INTERSTATE ROUTE H-1
ADDITION AND MODIFICATION OF FREEWAY ACCESS
(Kapolei Interchange Complex), Phase 3
Federal Aid Project No. NH-H1-1(271)

SHEET No. R-15 OF 167 SHEETS

GUARDRAIL DETAIL AND NOTES

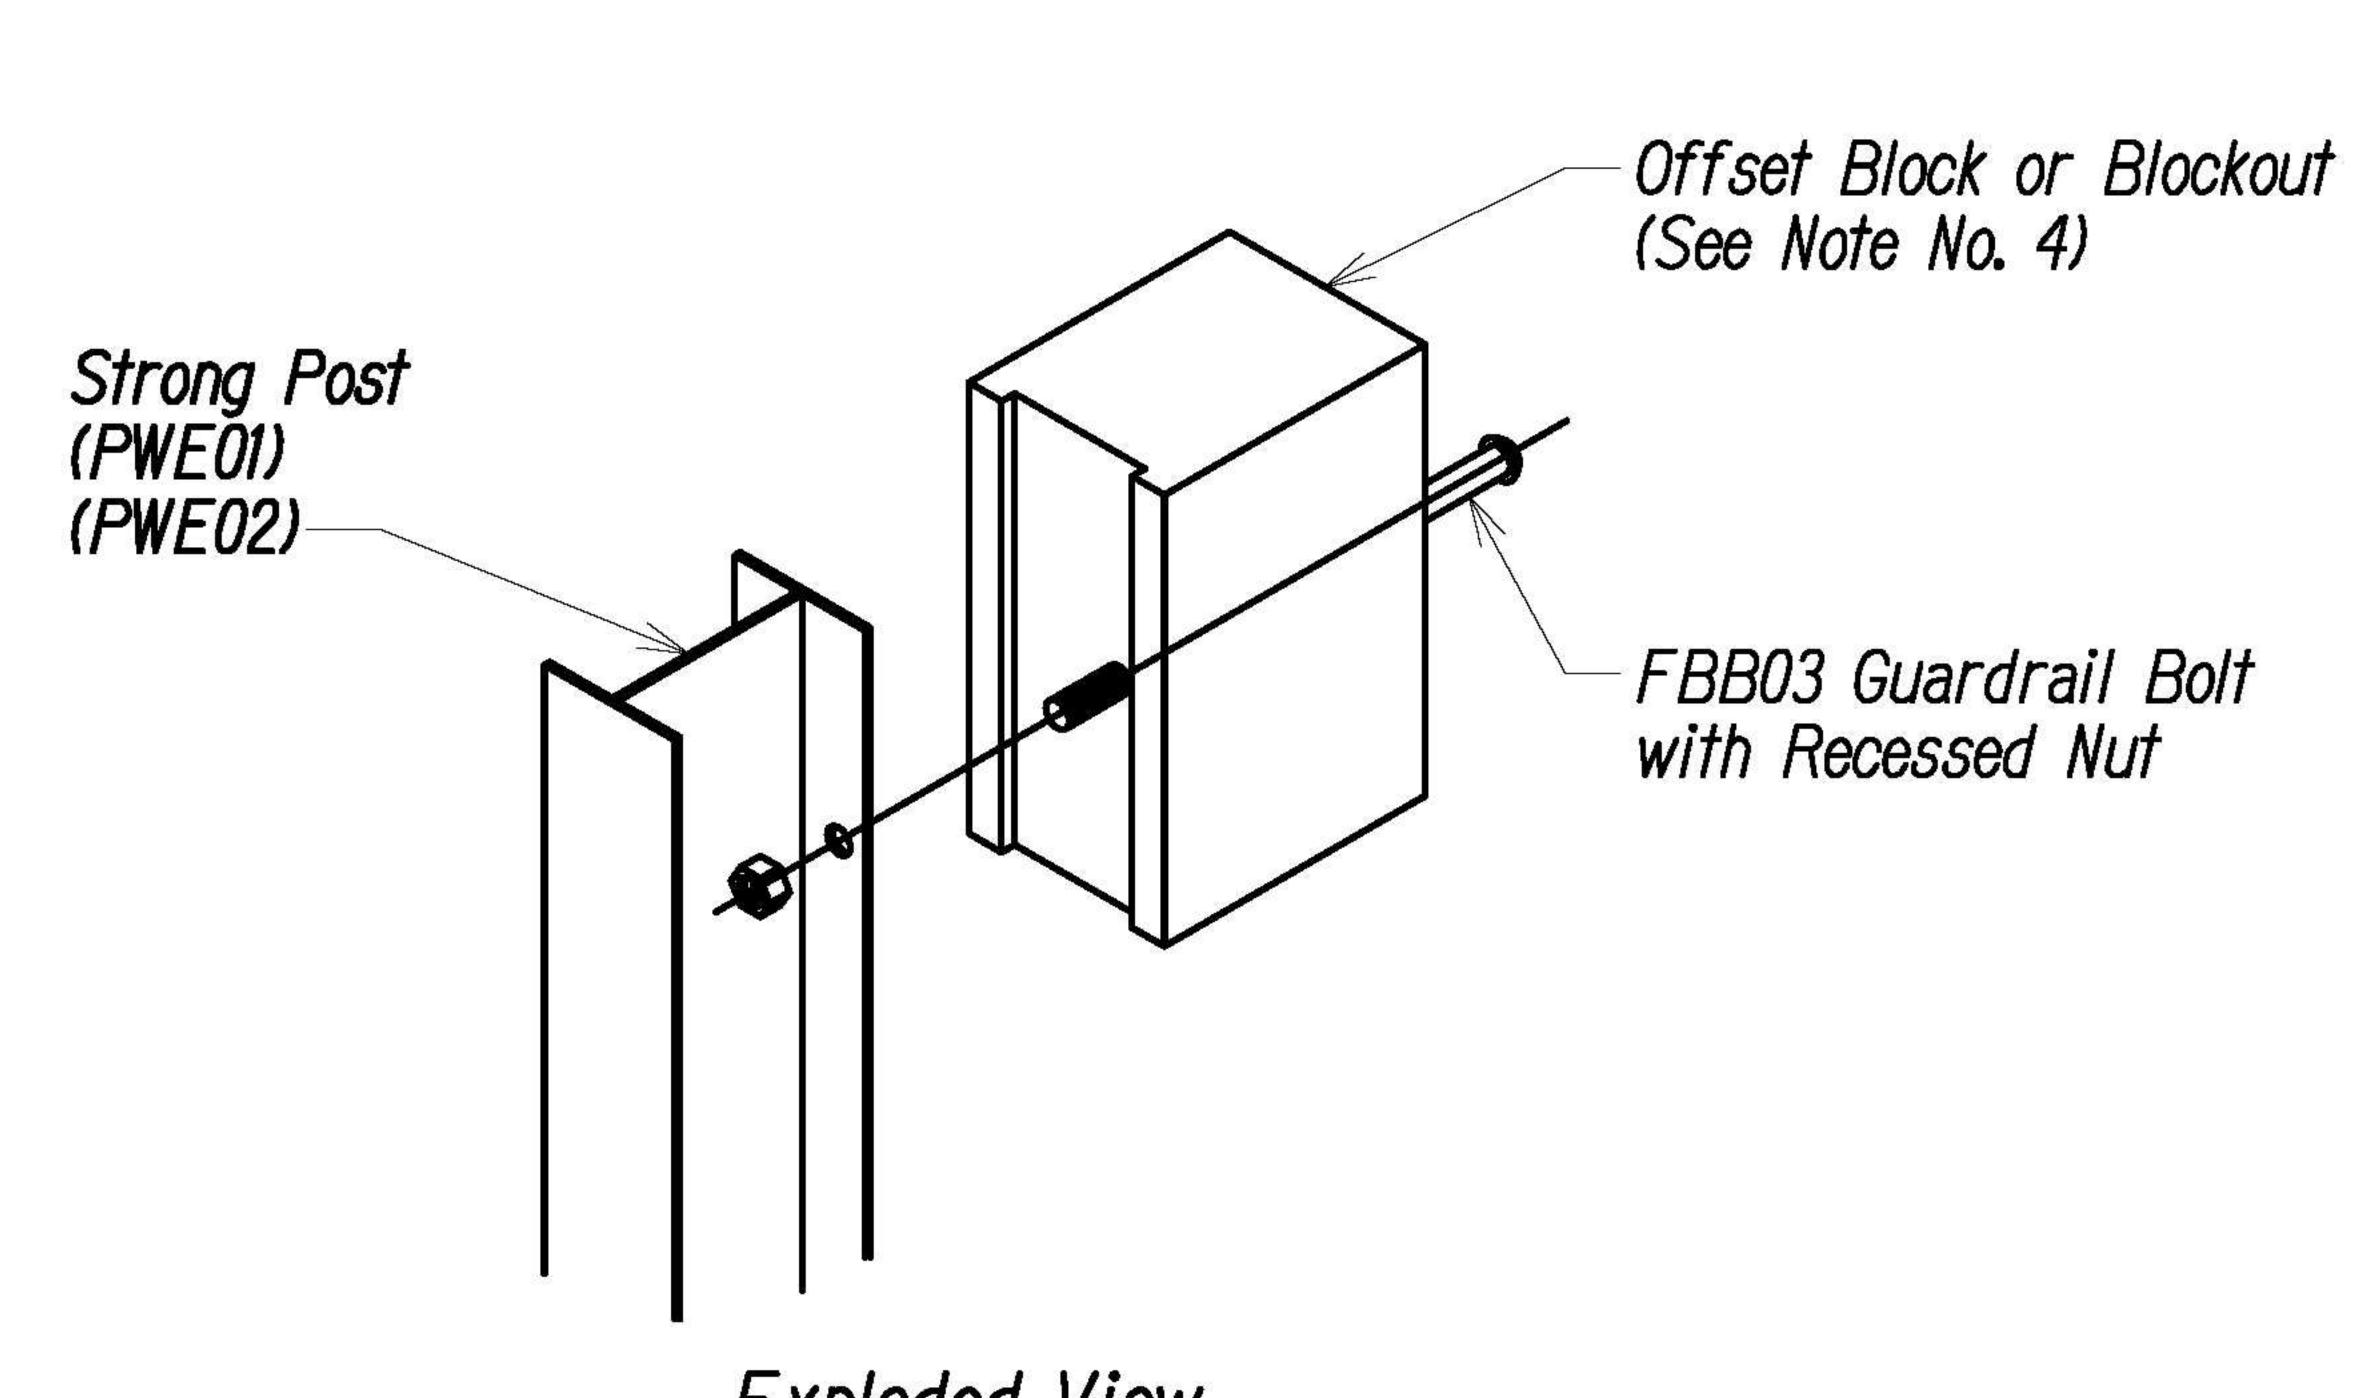
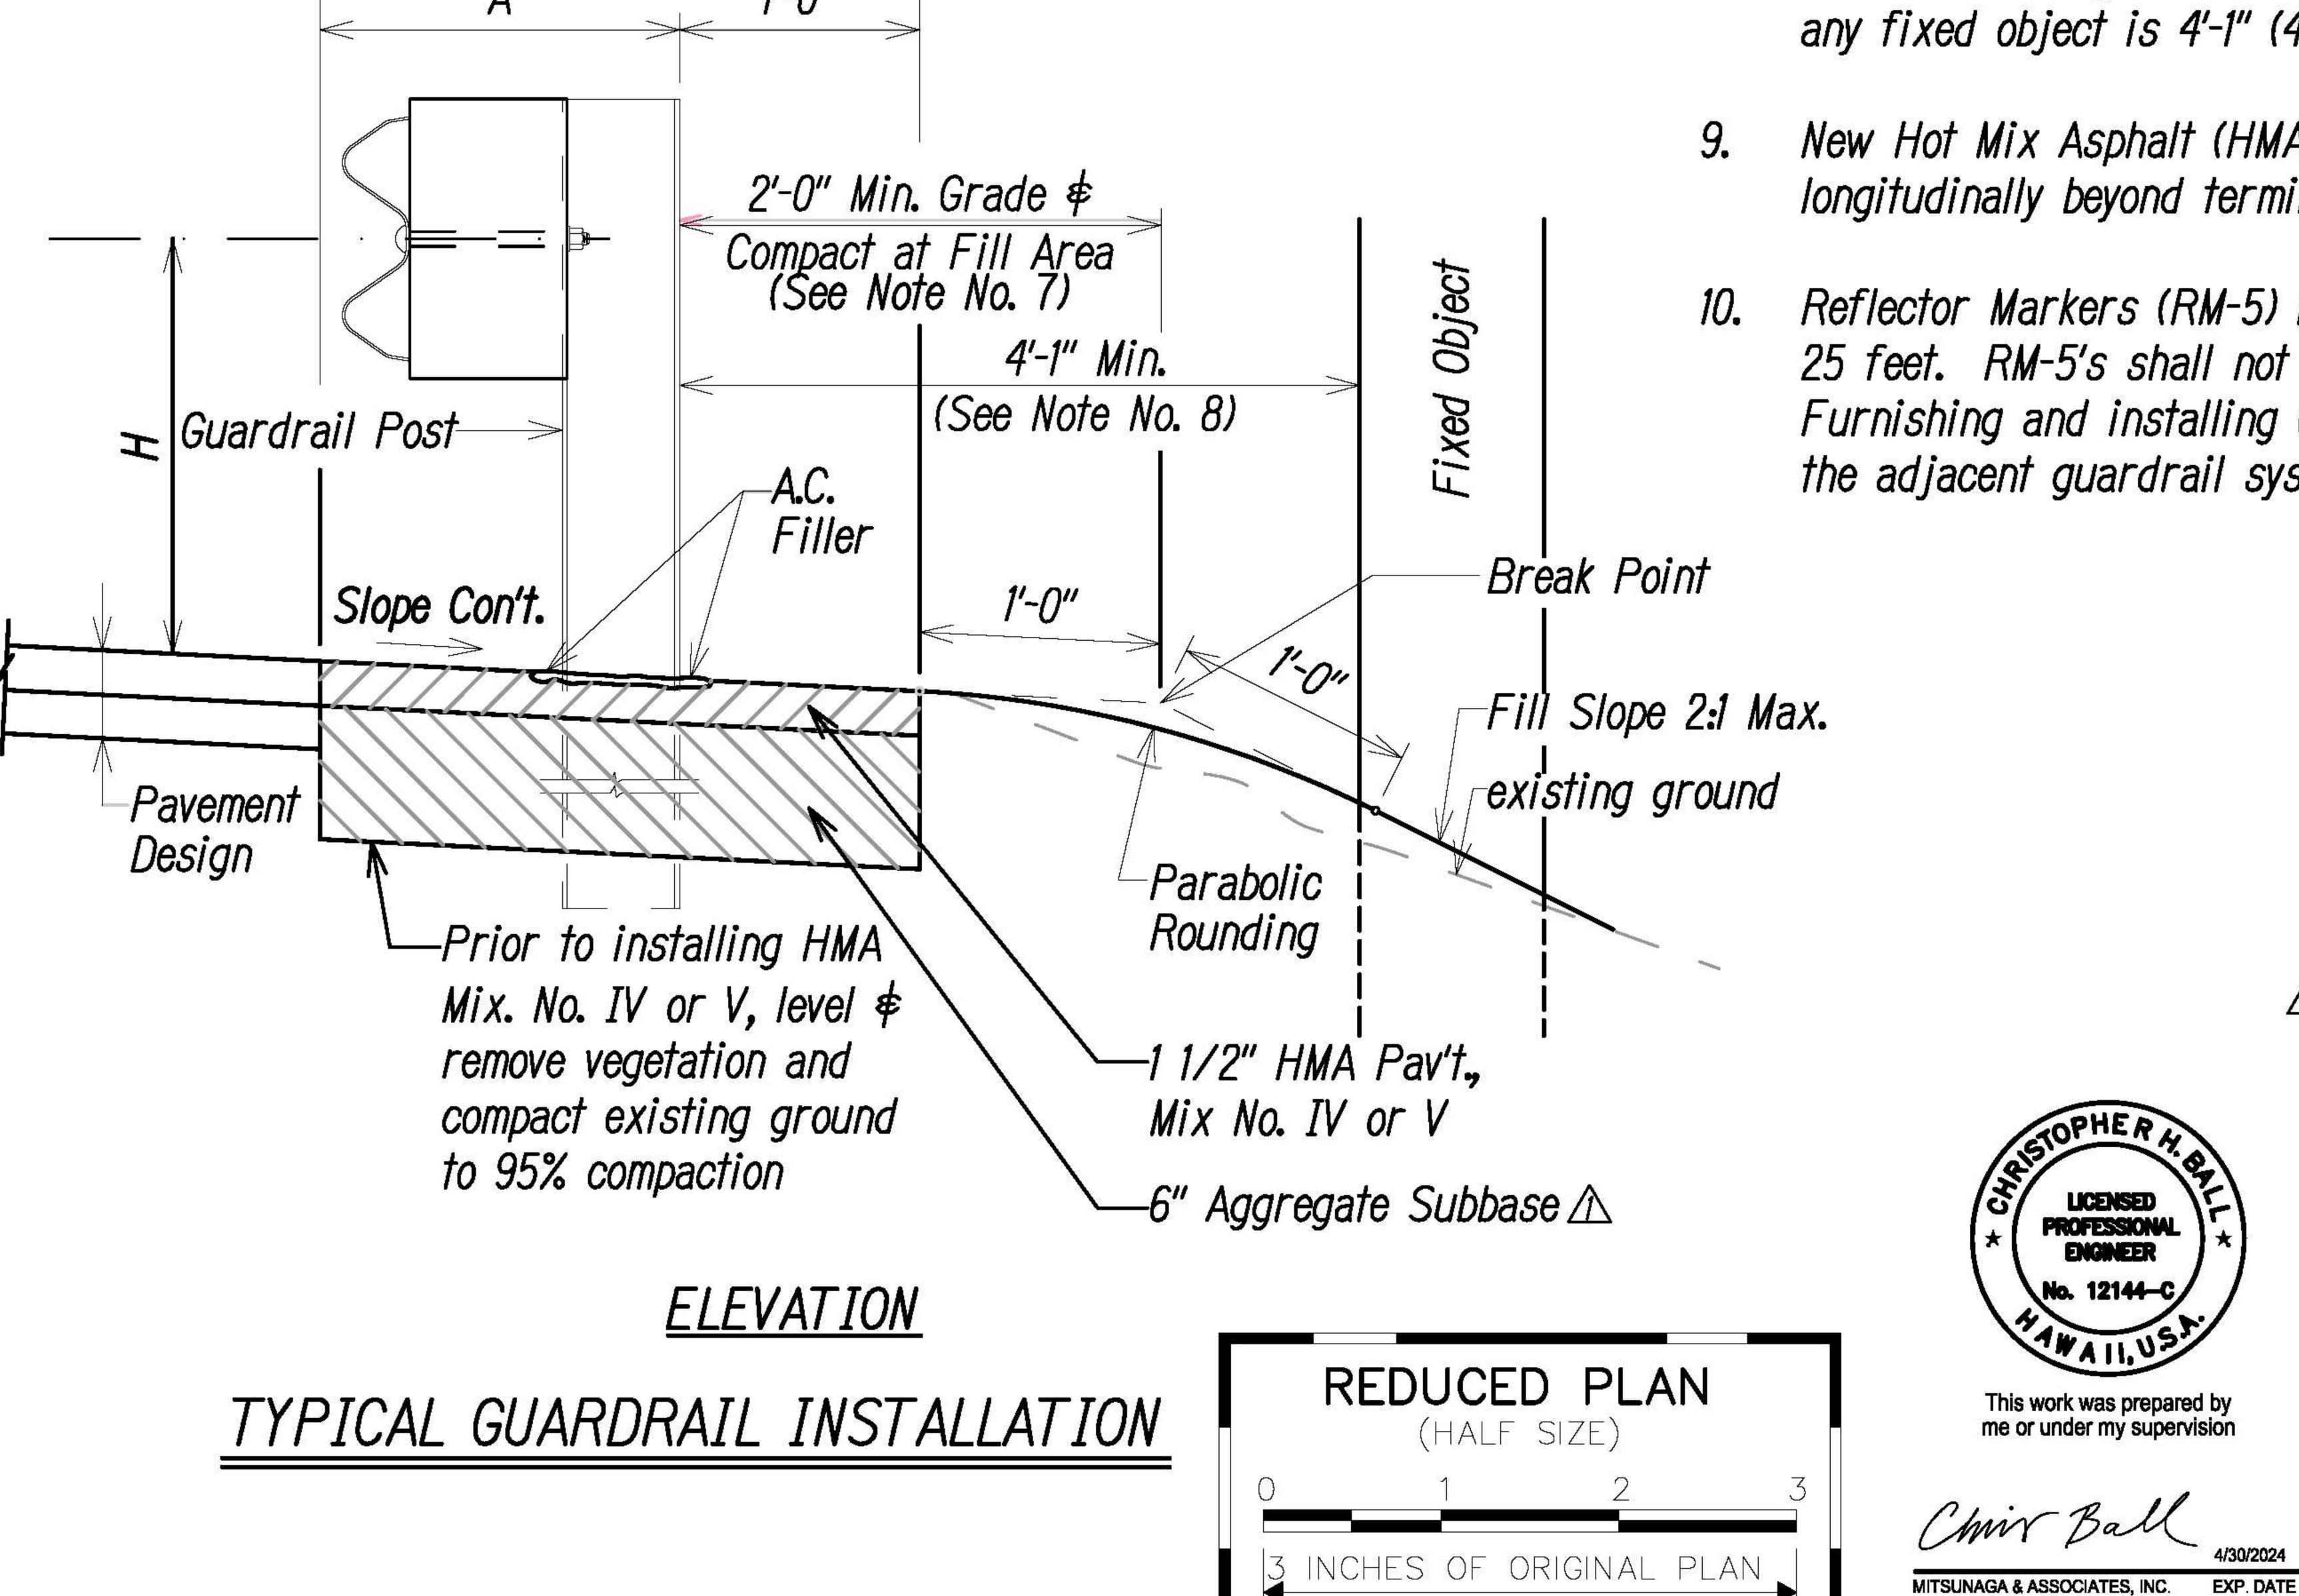
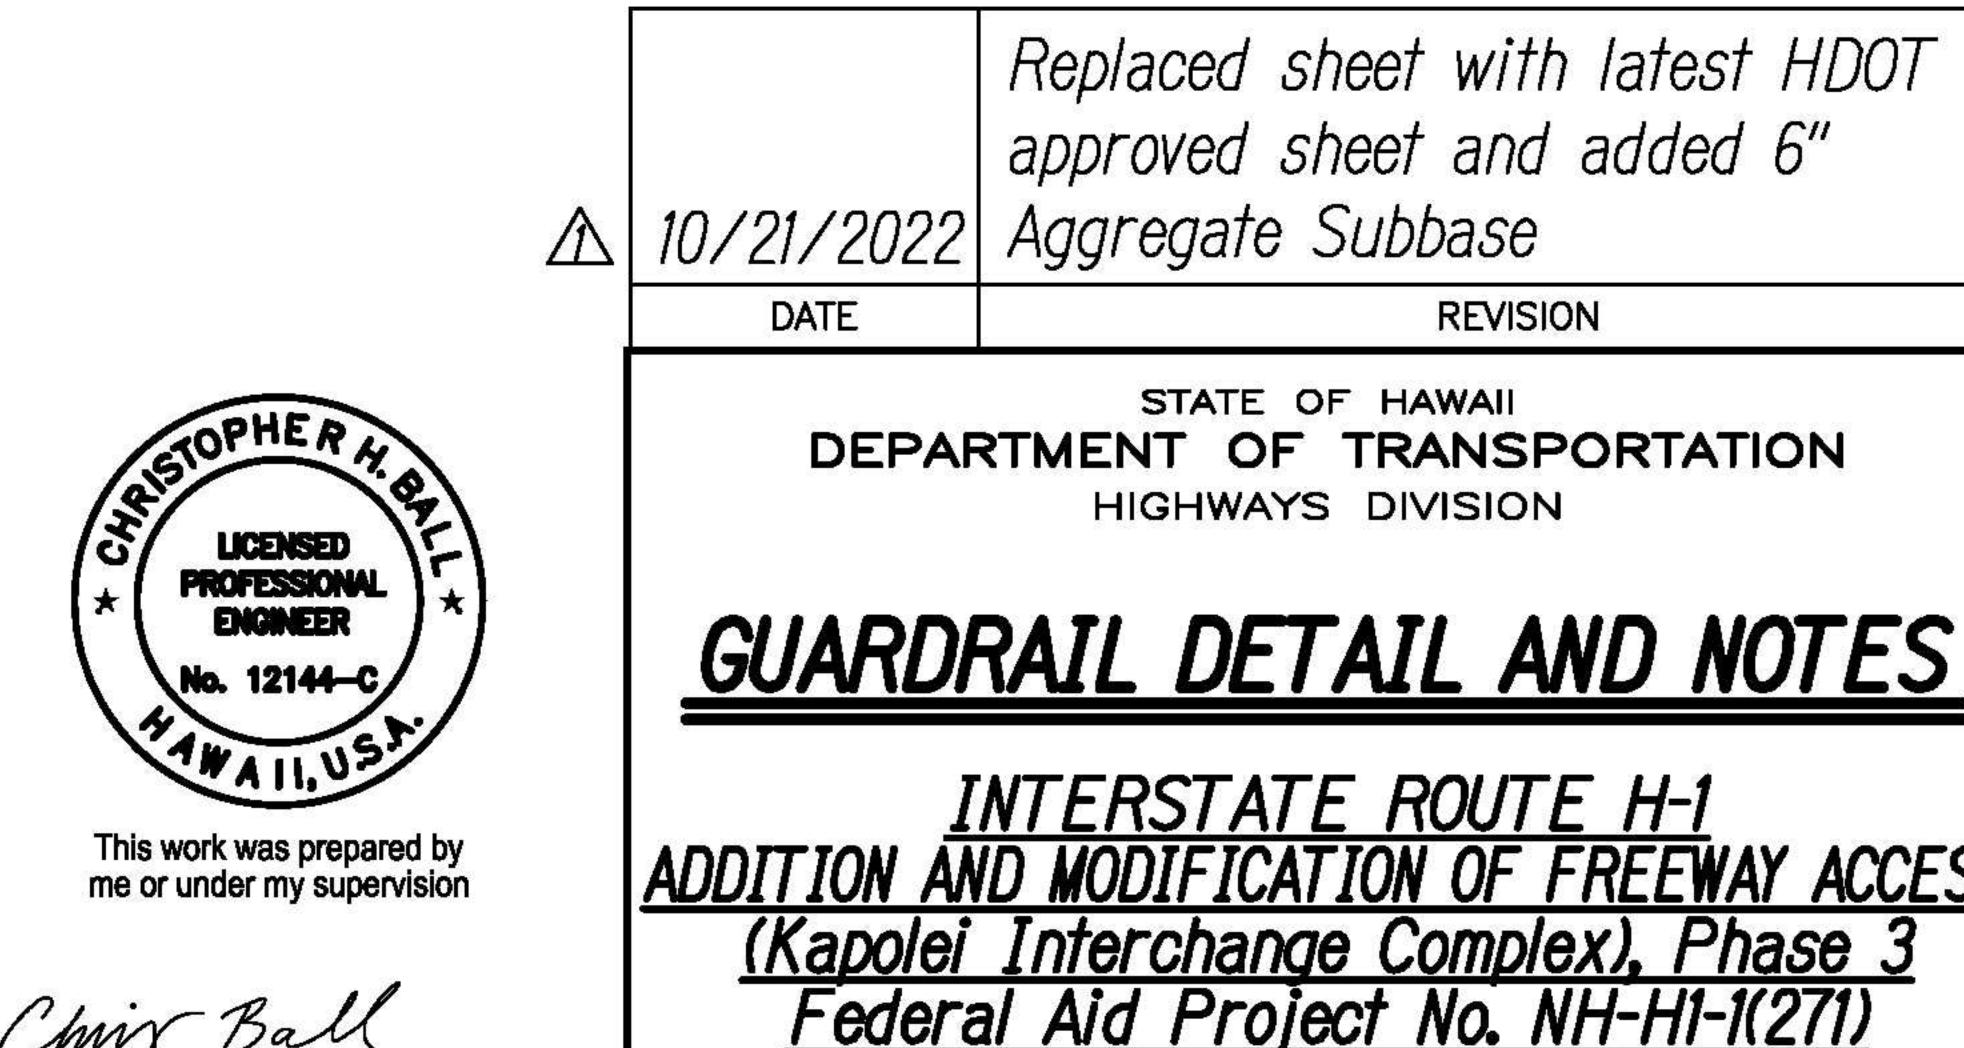
approved sheet and added 6" 10/21/2022 Aggregate Subbase STATE OF HAWAII DEPARTMENT OF TRANSPORTATION HIGHWAYS DIVISION
